May 11, 2021

Re: Bioscience 5  
Martin/Martin, Inc. Project No.: 19.0015  
City of Aurora Planning Department: 2019-8005-00

## PLANNING DEPARTMENT COMMENTS

**BIOSCIENCE 5**  
CONCEPTUAL SITE PLAN  
FITZSIMONS INNOVATION COMMUNITY  
FILING NO. 2  
LANDSCAPE PLAN

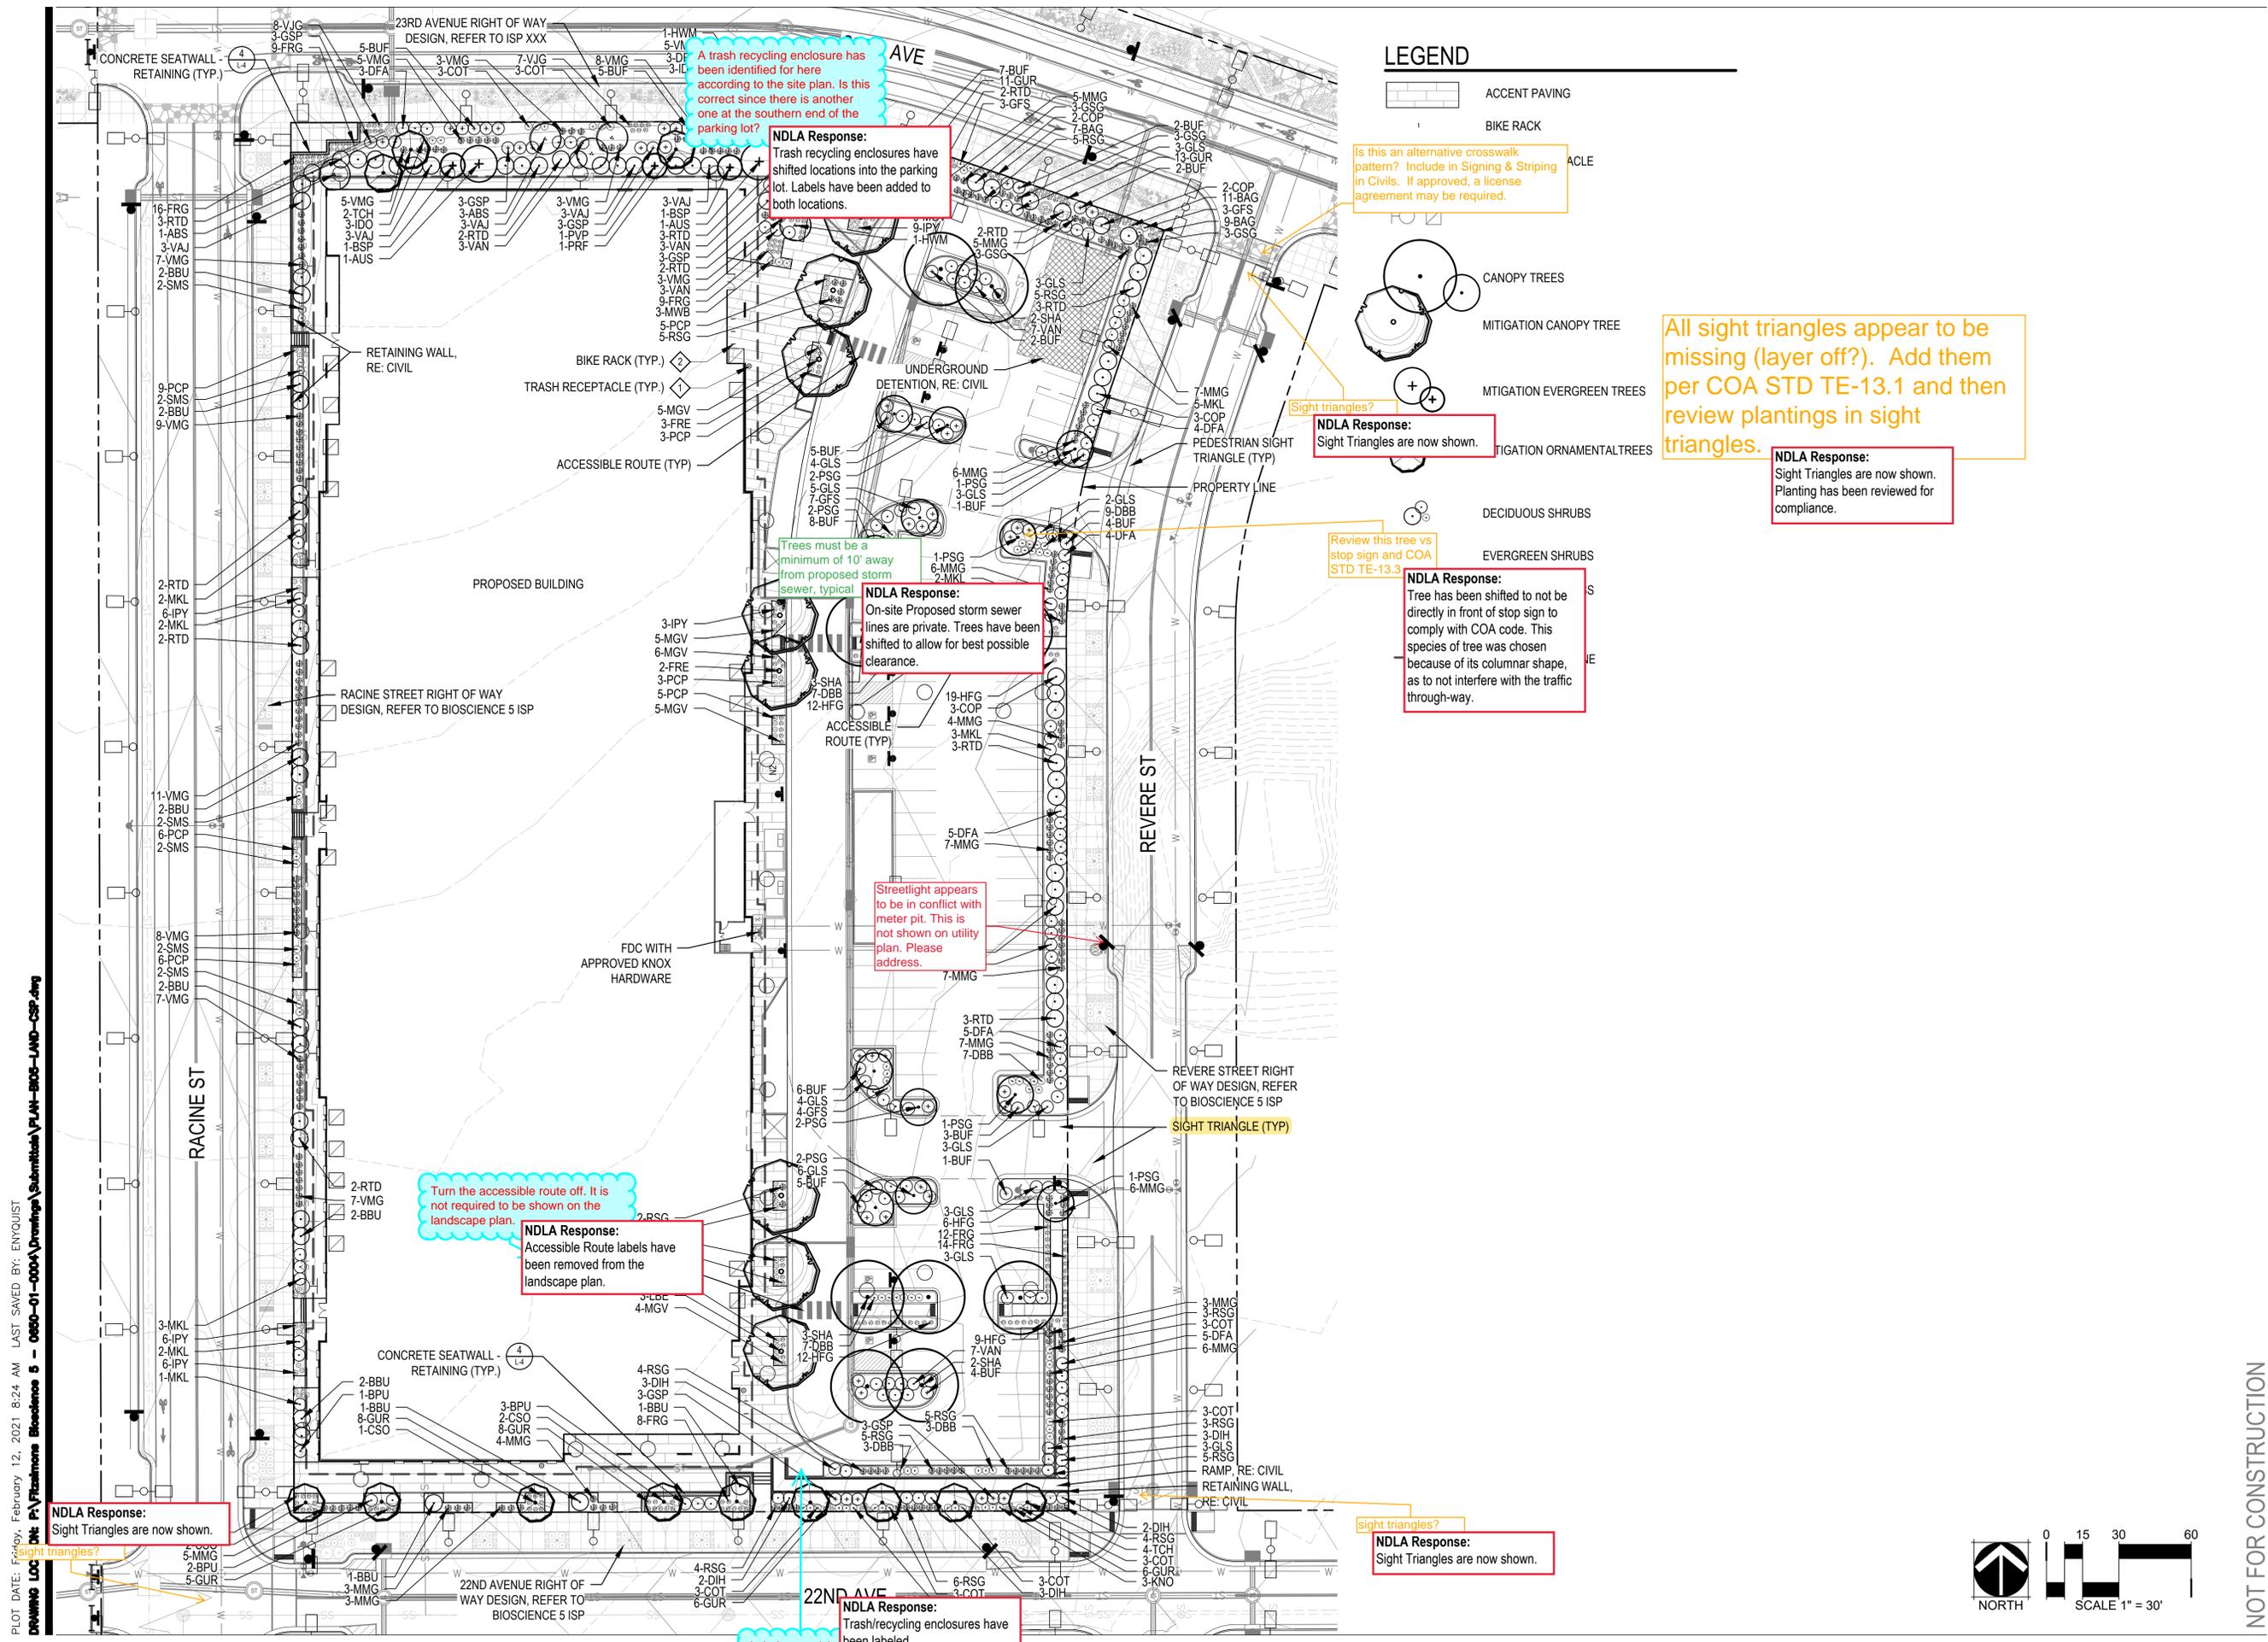
A trash recycling enclosure has been identified for here according to the site plan. Is this correct since there is another one at the southern end of the parking lot?

Is this an alternative crosswalk pattern? Include in Signing & Striping in Civils. If approved, a license agreement may be required.

All sight triangles appear to be missing (layer off?). Add them per COA STD TE-13.1 and then review plantings in sight triangles.

Sight triangles?  
**NDLA Response:**  
Sight Triangles are now shown.

Review this tree vs stop sign and COA STD TE-13.3

Trees must be a minimum of 10' away from proposed storm sewer, typical  
**NDLA Response:**  
On-site Proposed storm sewer lines are private. Trees have been shifted to allow for best possible clearance.

Streetlight appears to be in conflict with meter pit. This is not shown on utility plan. Please address.

Turn the accessible route off. It is not required to be shown on the landscape plan.

Label as trash/recycling enclosure

**NDLA Response:**  
Trash recycling enclosures have shifted locations into the parking lot. Labels have been added to both locations.

**NDLA Response:**  
Sight Triangles are now shown. Planting has been reviewed for compliance.

**NDLA Response:**  
Tree has been shifted to not be directly in front of stop sign to comply with COA code. This species of tree was chosen because of its columnar shape, as to not interfere with the traffic through-way.

**NDLA Response:**  
Accessible Route labels have been removed from the landscape plan.

**NDLA Response:**  
Sight Triangles are now shown.

Sight triangles?  
**NDLA Response:**  
Sight Triangles are now shown.

**NDLA Response:**  
Trash/recycling enclosures have been labeled.

**4 WEST ELEVATION**  
 1" = 20'-0"

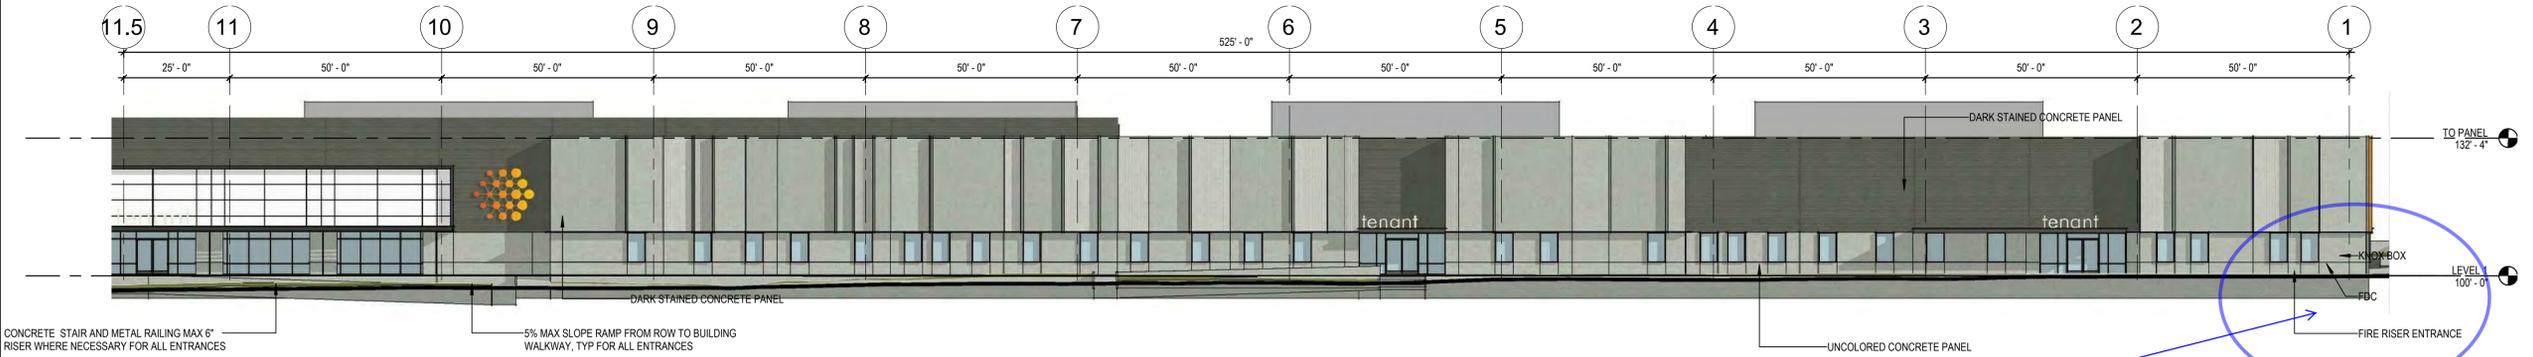
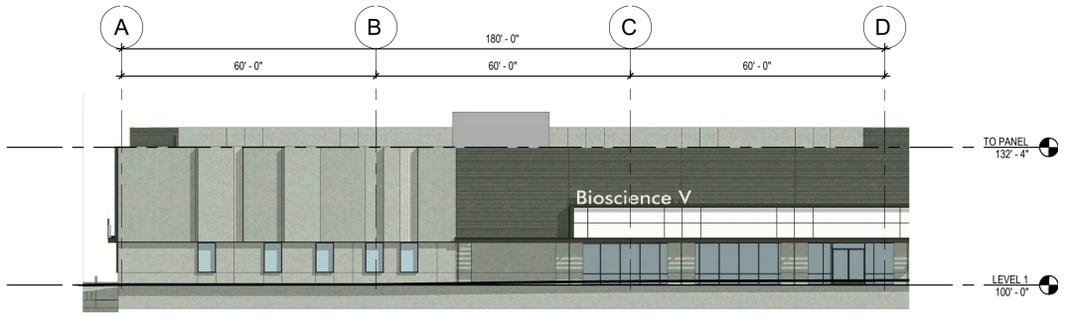
This location for FDC, Knox box, & Riser room does not match the site plan. Please verify.

Response:  
 Location revised
